**Application reference: S62A/2024/0075**

**Proposal: Reserved matters (appearance, landscaping, layout and scale); pursuant to outline planning permission ref: S62A/2023/0031 for the erection of up to 55 dwellings, associated landscaping and open space, with access from Knight Park**

**Location: Land North of Thaxted Road, Saffron Walden**

Extract 1 -Milestone Transport Statement (ref 23075/Reports/TS) – Appendix 4 (Swept Path Analysis Single Decker Bus – Drawing 23075-TK01)

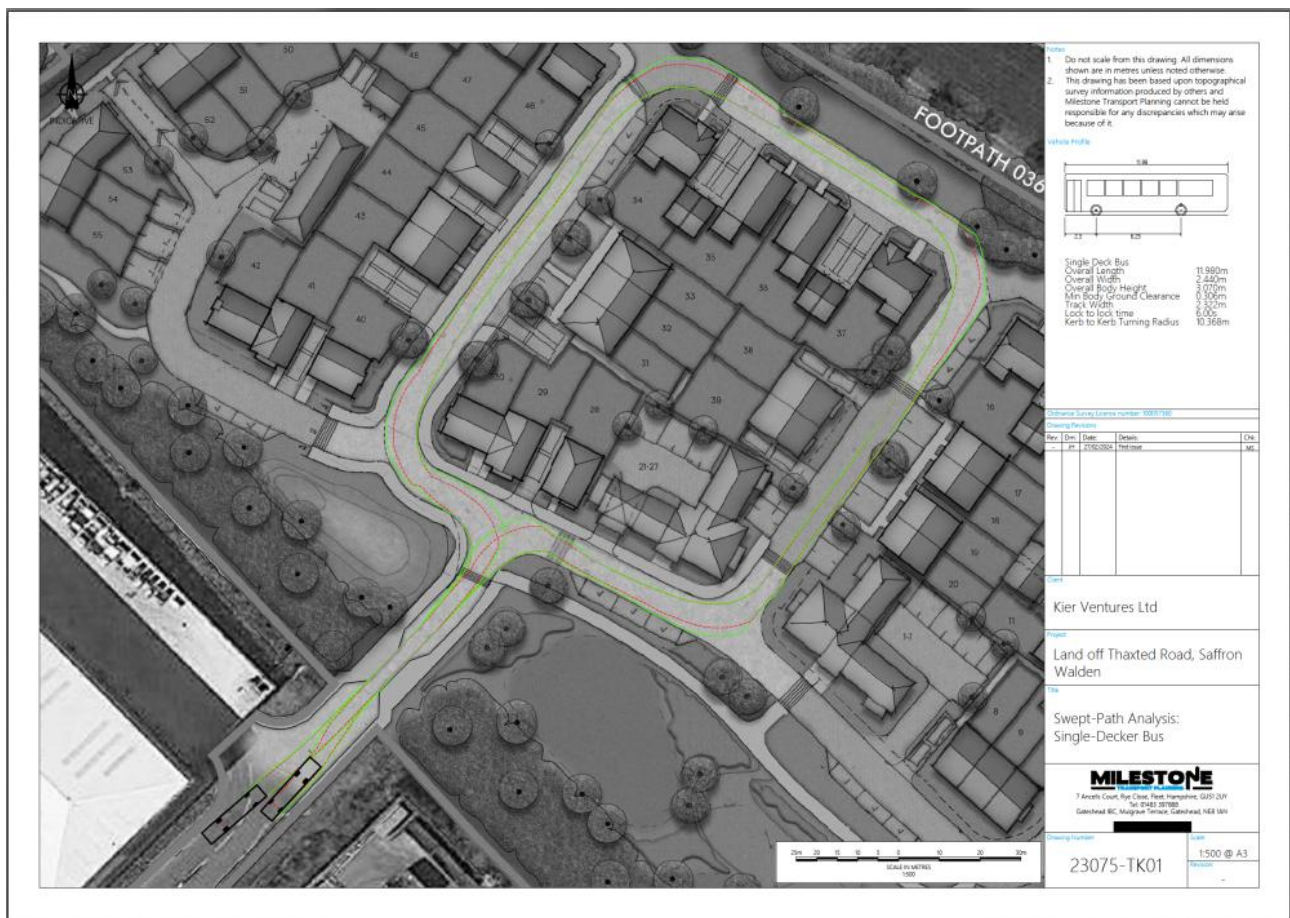
ECC go on to state that *'furthermore the design presented at the reserved matters stage now shows a shared surface as opposed to a carriageway with a separate footway facility presented at the outline stage'*.

This is factually incorrect. None of the approved plans show footways within the development itself, with the approved Access Plan only showing secondary and tertiary roads within the development with no further detail. Indeed, the non-approved 'Sketch Site Layout' plan in fact showing that many of the roads within the development do not have footways. An extract of the vehicle tracking plan contained within the Transport Statement underpinning the outline permission clearly indicates that the intended bus loop around the site would run through elements of road hierarchy that are shared surfaces without footways present.

This design can be replicated through the linking of the top-most private driveways, as previously set out to ECC Highways and already before the Inspector (ref rebuttal letter dated 31.03.25, Appendix 2 – email dated 11.03.25 to ECC Highways). The attached drawing ACE 2404920-SK02 illustrates that a single deck bus can loop around this central section should the Inspector agree with this requirement of the scheme, and this approach is consistent with that presented in the Milestone Transport Statement noted above.
